PUBLIC UTILITIES COMMISSION OF THE STATE OF CALIFORNIA

SAFETY AND ENFORCEMENT DIVISION
UTILITIES SAFETY BRANCHRESOLUTION SU-40
Date: October 9, 1996R E S O L U T I O NRESOLUTION SU-40, ORDER AUTHORIZING RULE CHANGES TO
GENERAL ORDERS (G.O.s) 95 AND 128, RULES FOR
OVERHEAD AND UNDERGROUND ELECTRIC AND COMMUNICATIONS
LINE CONSTRUCTIONSUMMARY

RULES FOR OVERHEAD LINE CONSTRUCTION, GENERAL ORDER NO. 95

Requirements for Supply Lines

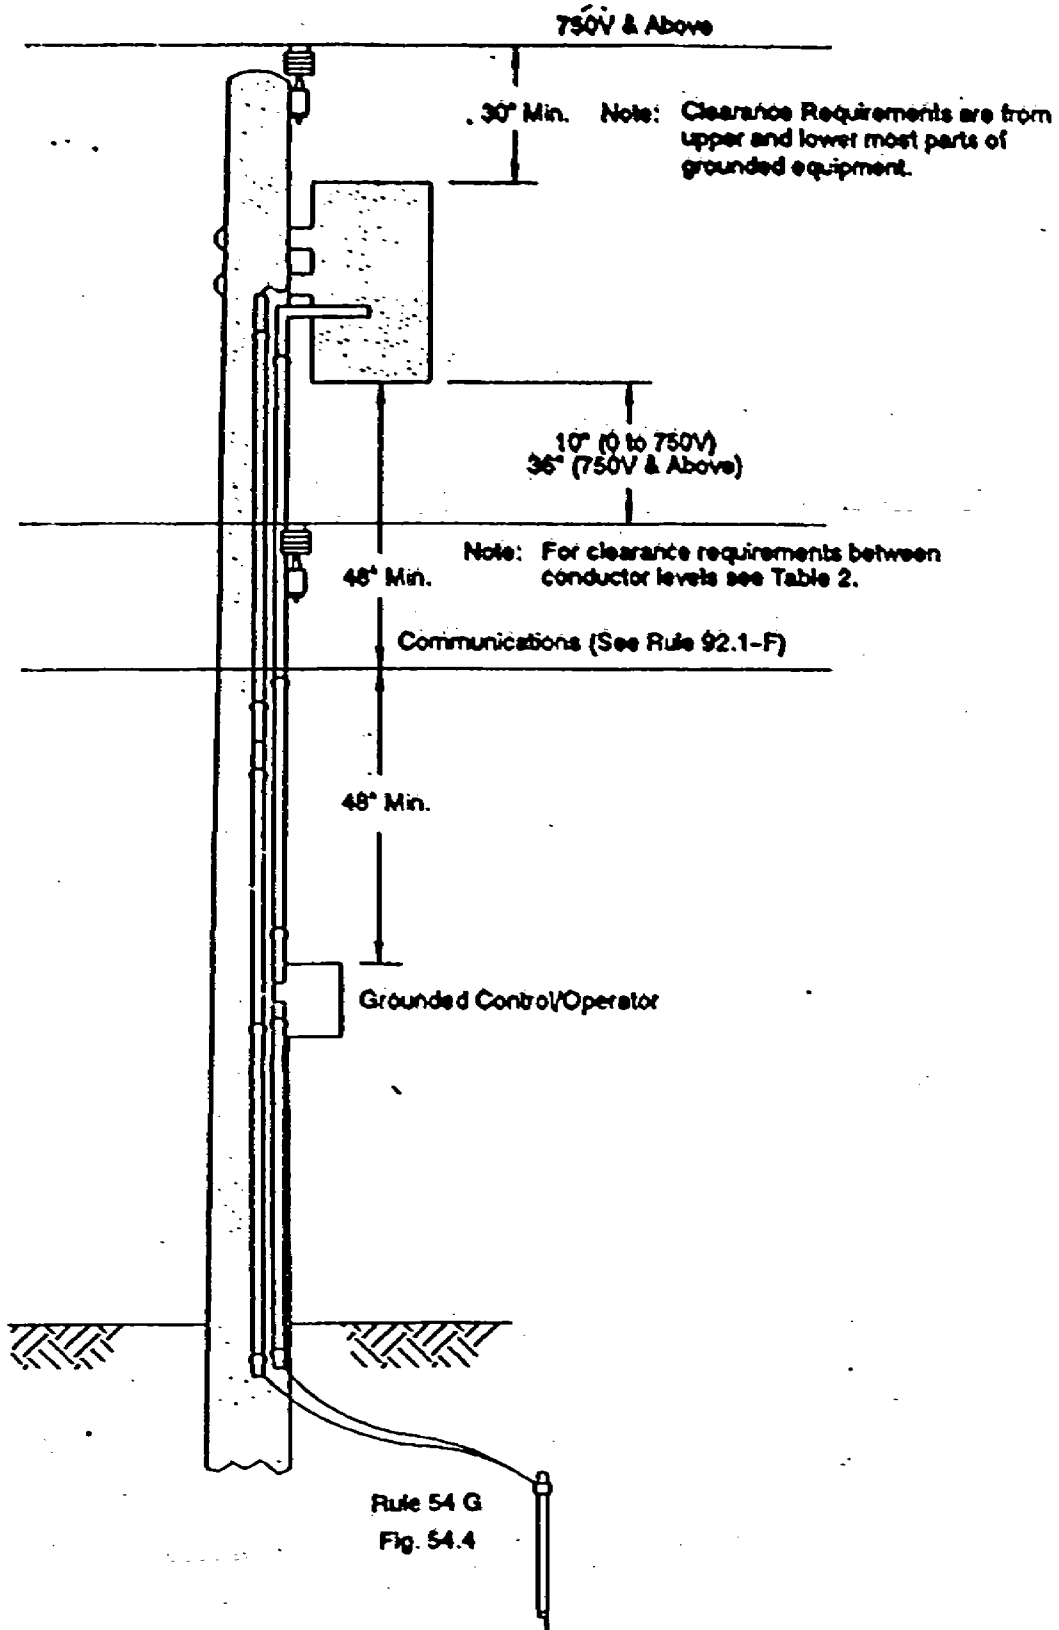
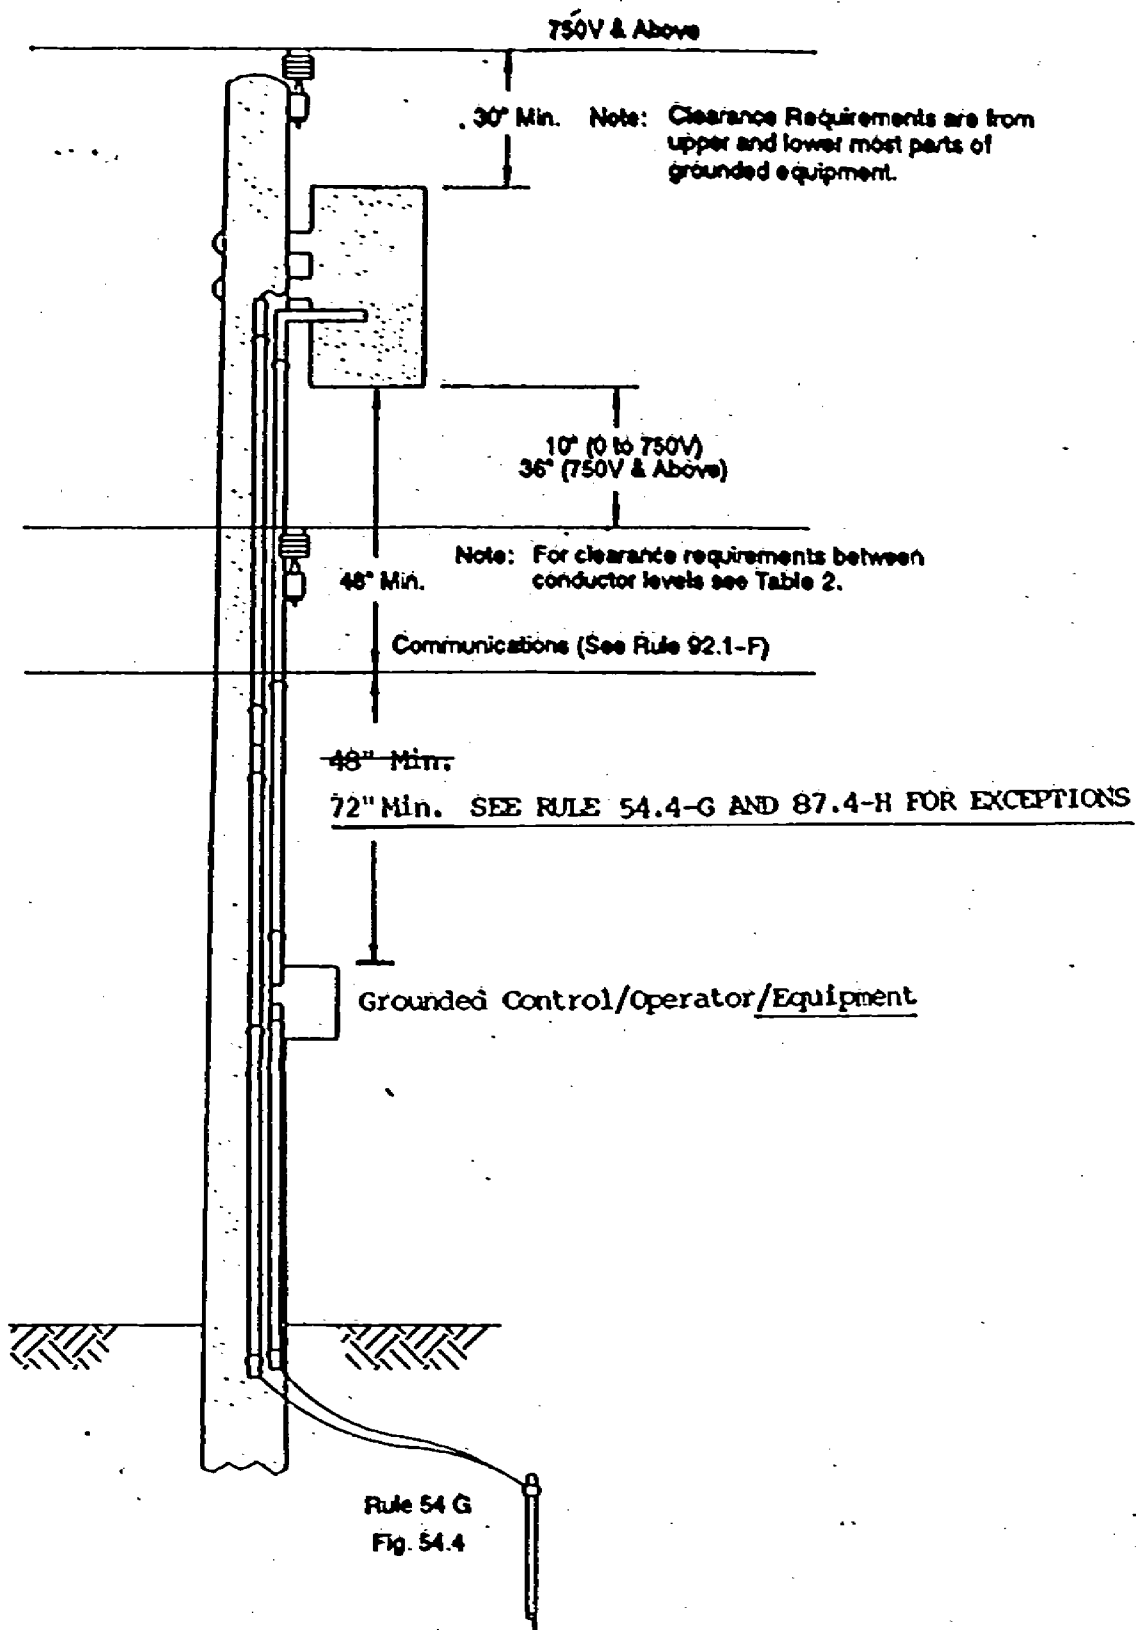
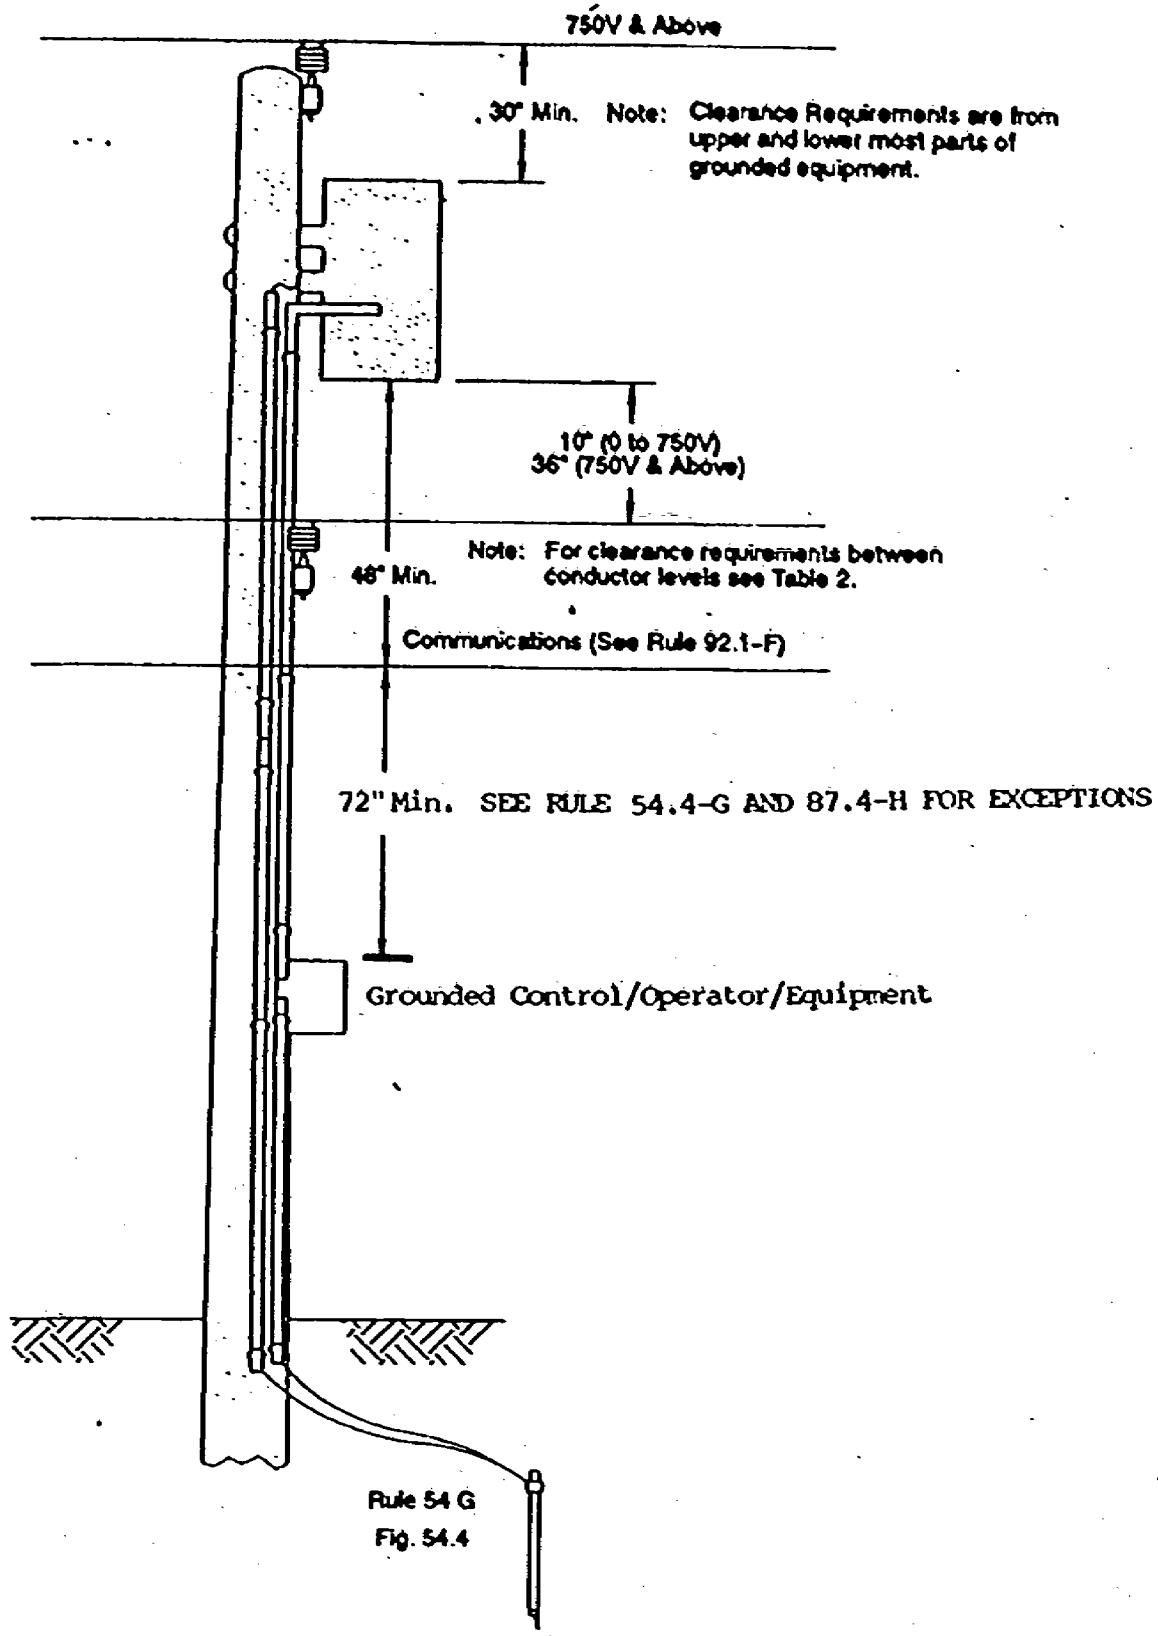
The present language addresses communication line conductors (open wire) but not cable and messenger which is the prevalent construction. This proposal will change communication line conductors to communication cable and messengers.

This proposal also modifies clearance between supply grounded metal boxes, hardware or metal cases for equipment placed below communication level, and communication owned cables and messengers.

All grounded metal boxes, hardware and metal cases for equipment, on non-metallic poles or non-metallic structures shall be a minimum of 36 inches above and 30 inches below the next level of unprotected conductors. Such equipment shall have a minimum clearance of 48 inches above or 72 inches below communication line conductors, cables and messengers of different ownership. See Figure 54-4.

(5) The 72 inches may be reduced to not less than 48 inches where a communication cable does not have a pole mounted drop distribution terminal located above the grounded metal box, hardware or metal case for equipment, or where the grounded metal box, hardware or metal case for equipment is securely bonded to the communication cable and/or messenger.

(6) The 72 inches may also be reduced to 48 inches when the grounded metal box, hardware or metal case for equipment is on the opposite side of a pole from a pole mounted communication drop distribution terminal.

FIGURE 54-5

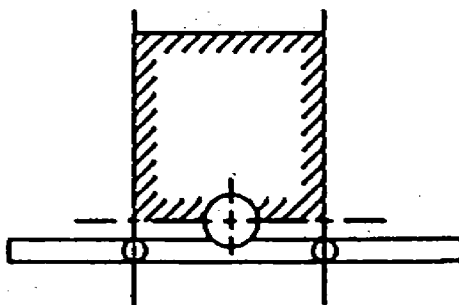
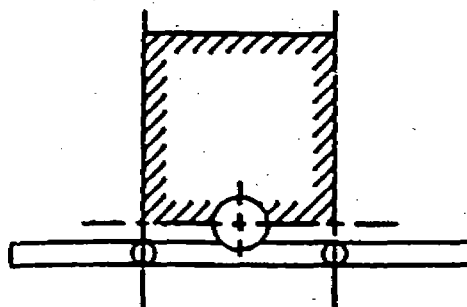
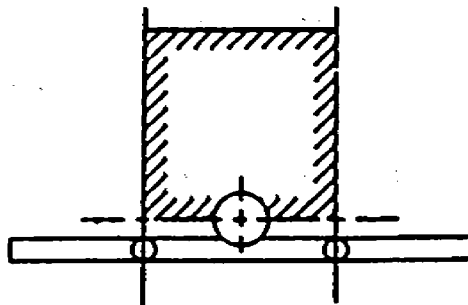
This proposed rule change will help clarify the language of Rule 54.7. Minor changes in format have been made. Inserting all allowable climbing space obstructions allows this rule to stand alone, removing the need to refer to other rules in the Order. Lightning arresters have been added to allowable working space obstructions as they were inadvertently overlooked with the SU-5 change package. Removing the 6 foot clearance requirement and the exception in Rule 54.4-D8 removes an unnecessary requirement without affecting safety to workers or the general public.

(1) **Dimensions Where Line Arms Only Are Involved:** The climbing space where line arms without related buck arms are involved on poles or structures shall be on one side or face of the pole, with the center line of pole approximately midway on one side of the climbing space (See Figure 54-5), and shall have the following dimensions:

Fig. 54-22

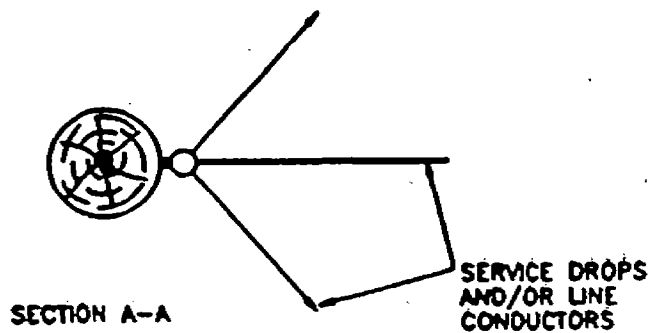
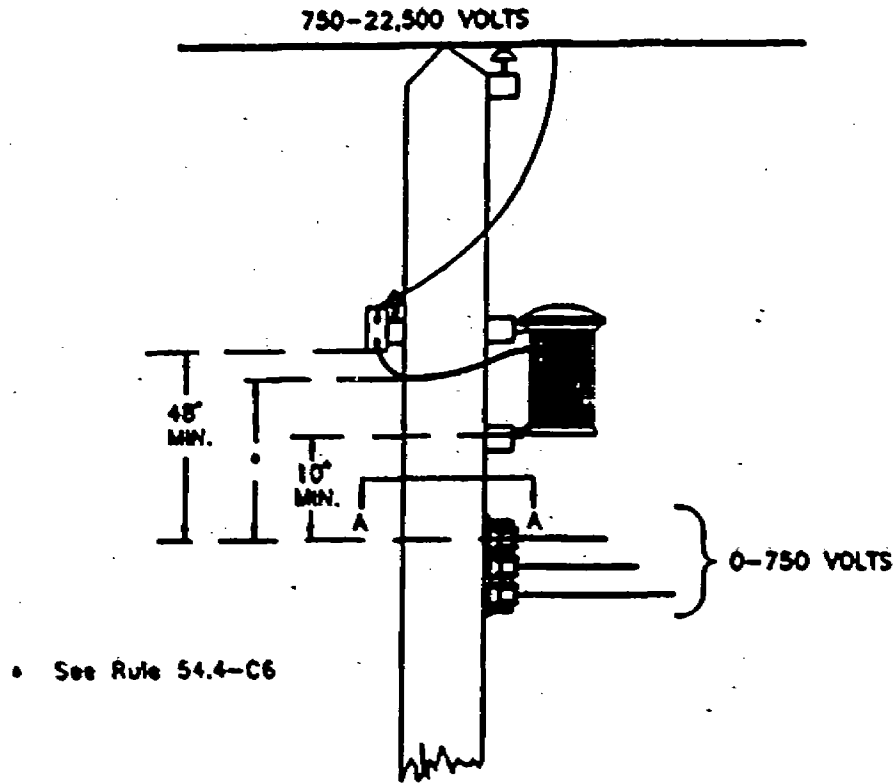
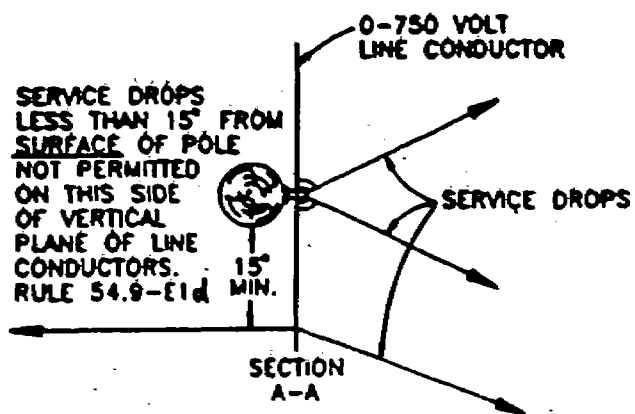
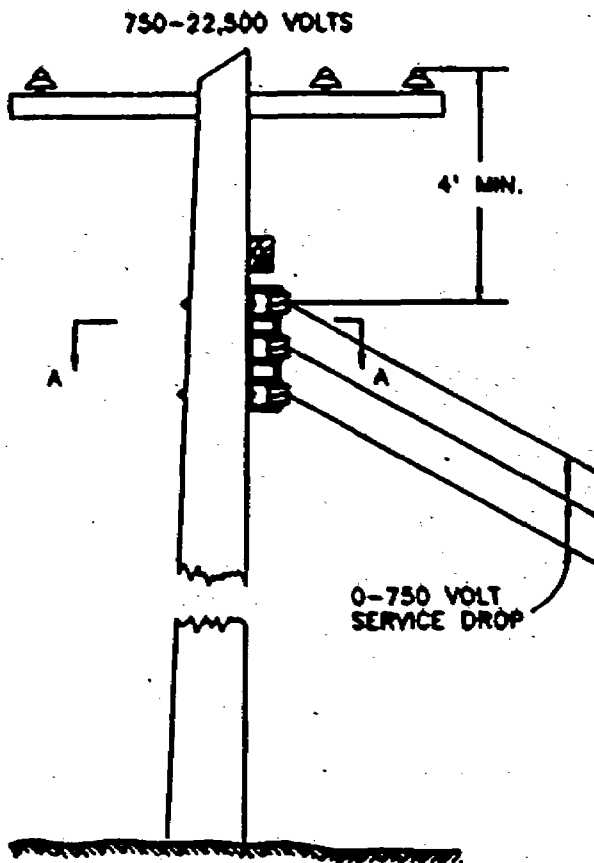
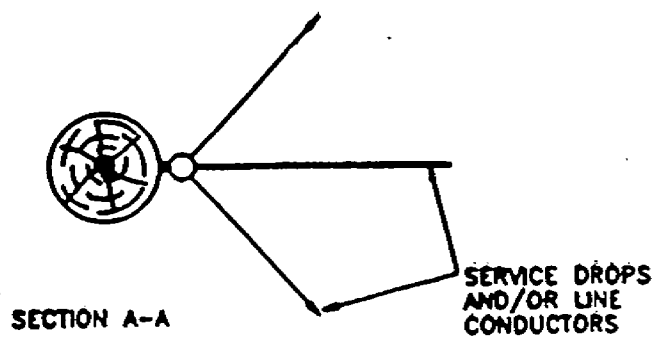
- ~~(a) 4 feet below unprotected line conductors; and~~
- ~~(b) As specified in Rule 54.4-C 6 below the lowest point of the drip loop of the primary leads to the transformer(s); and~~
- ~~(c) 10 inches below the lowest part of the equipment case(s) or hanger(s).~~

~~(See Figure 54-22)~~

- (a) 4 feet below unprotected line conductors; and
- (b) As specified in Rule 54.4-C 6 below the lowest point of the drip loop of the primary leads to the transformer(s); and
- (c) 10 inches below the lowest part of the equipment case(s) or hanger(s).

(See Figure 54-22)
